MEMORANDUM FOR : Chief, WCFO

After testing the Advanced 918 Light Table Prototype and reviewing the specifications, we arrived at the following list of items to be modified or repaired.

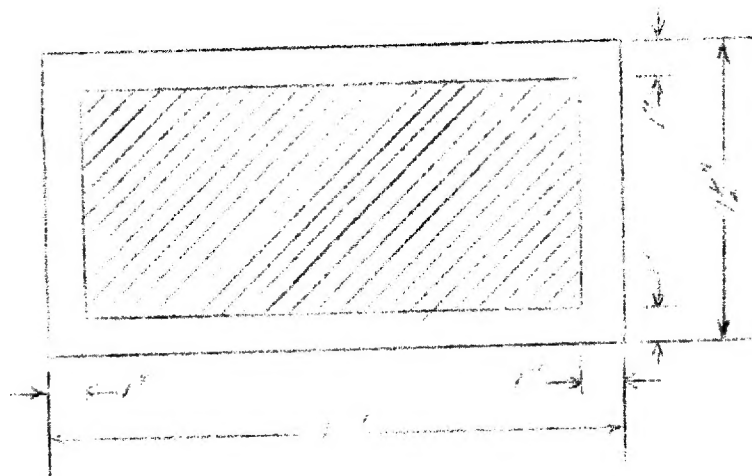
g. The illumination system must provide a maximum illumination of at least 2,000 ft. lamberts within a 2" radius of the geometric center of the illuminated area. The maximum linear brightness gradient must not exceed 15% between any two measurements taken within the shaded area shown on the diagram below, nor 25% anywhere within the illuminated area.
